Product hierarchy no. *			Part no.	SBU	Type / Description	Customer part no.
SBU	PG	PGU Type				
02	007	013	0000002404	See list below	Appliance outlet	5213

Modification of rating mark

5213 Appliance Outlet					0118.2202	
creation date	created by	release date	released by	notification no.	revision	page
2014-01-15	hotzar	2014-05-01	hotzar	26105	a	1 of 2

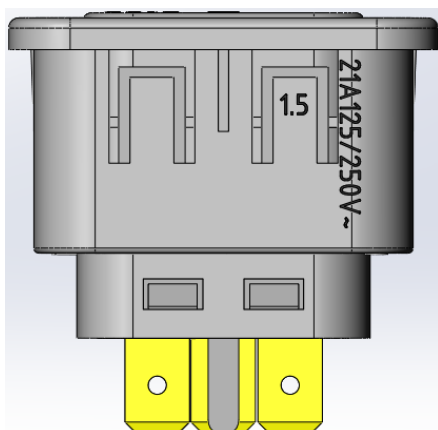
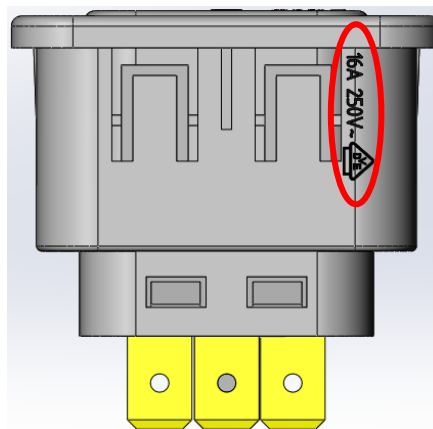
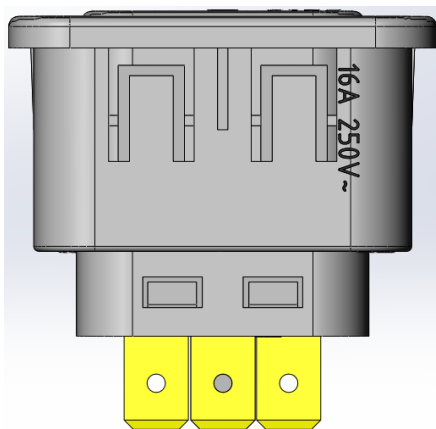
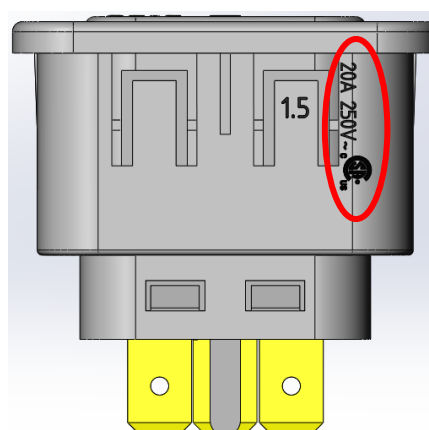
Change of rated current acc. to UL 60320

Old: 21A 125/250V~ new: 20A 250V~

Approvals   shifted

Old marking

New marking

Assignment approval mark to rated current. Rated current adjusted to UL 60320
